REVISED STAFF REPORT: NOVEMBER 12, 2025 REGULAR MEETING **PREPARED BY:** B. SALIE
APPLICATION NUMBER: HDC2025-00584
ADDRESS: 4224 CORTLAND
HISTORIC DISTRICT: RUSSELL WOODS-SULLIVAN
APPLICANT/PROPERTY OWNER: BRANDON JENKINS
DATE OF PROVISIONALLY COMPLETE APPLICATION: 10/29/2025
DATE OF STAFF SITE VISIT: 11/03/2025

SCOPE: REMOVE HISTORIC STEEL WINDOWS & INSTALL VINYL WINDOWS

Photos provided by applicant, show the historic steel casement window with significant rust and peeling paint on the trim and muntins

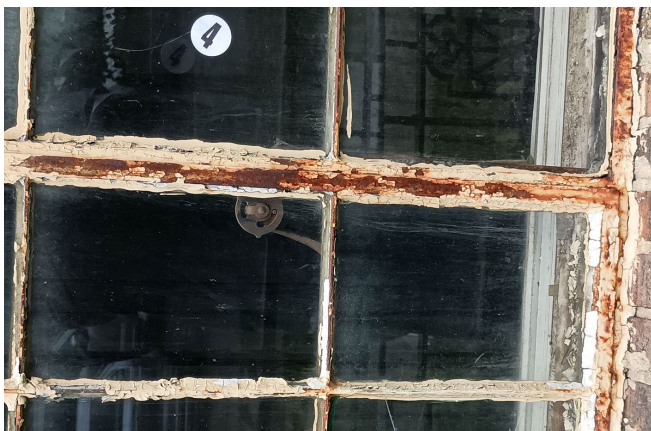
- The front bay of the house has retained its historic aged windows. The windows at the front of the house are a distinctive, character-defining feature for this property. Since time of designation, the window frame and muntins were painted, which is now rusted and peeled.

- It is staff's opinion that the deterioration and the build-up of rust over the years show the windows to be beyond repair. However, vinyl is not an appropriate replacement window type for historic buildings, in particular for the thin profiles of steel casement windows:

- While the existing historic steel casement windows appear to be deteriorated beyond feasible repair, the proposed windows are not in-kind matches to the historic windows at this property. The historic steel windows, per NPS Standards (#6) and related Guidelines, may only be replaced by a window that "shall match the old in design, color, texture, and other visual qualities and, where possible, materials." Vinyl windows are not good matches for historic prototypes.
